## For GMA-9's Consideration During Current (Oct 1 – Dec 31, 2015) Public Comment Period on Desired Future Conditions

(Dec 22, 2015)

Rene A. Barker

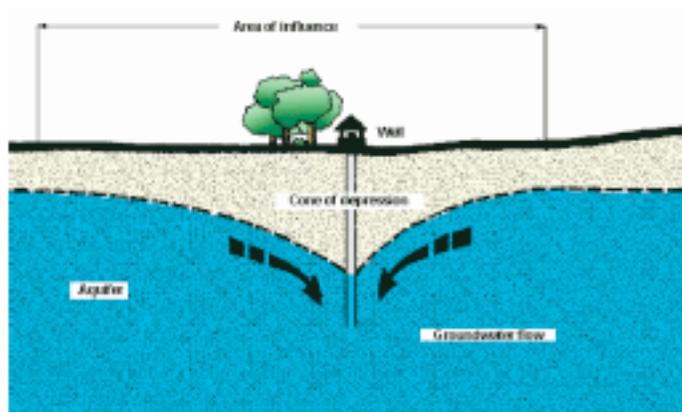
6) In order for the GAM to represent the real groundwater-flow system, it simulates the average or net effect of all modeled conditions and stresses that are accounted for within areas represented by a single model cell. As a consequence, the regional-scale GAM typically underestimates the magnitude of actual water-level fluctuations in individual wells that result from nearby pumping. Although the difference between simulated water-level conditions (applicable to one-square mile model cells) and actual, real world conditions depends on several factors, it is not uncommon in heavily pumped areas for individual wells, stream reaches, or springs to go dry or cease flowing at levels significantly different than simulated counterparts that represent net conditions—conditions averaged across entire (one-square mile) grid cells. ***In other words, the regional-scale design of the GAM limits its capacity to simulate worst-case or conservative perspectives relative to site-specific conditions associated with single wells, specific stream reaches, and small springs and seeps.***

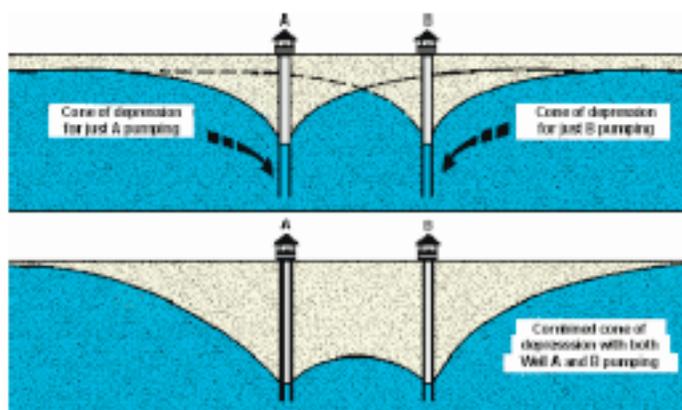
11) Given that the current “30-foot” DFC allows for additional development of an already heavily pumping groundwater supply, it is inevitable that future wells will be closer together, thereby increasing the potential for well interference. The illustration below shows how closely packed wells compete for the same groundwater, thus causing water levels to be substantially lower in intervening areas of overlapping drawdown. ***A continuation of the “30-foot” DFC will likely exacerbate the potential for well interference and additional water-level decline in areas affected by existing groundwater development.***

(A) Typical cone of depression without influence of nearby pumping.

(B) Well interference caused by overlapping cones of depression that results from insufficient well spacing.
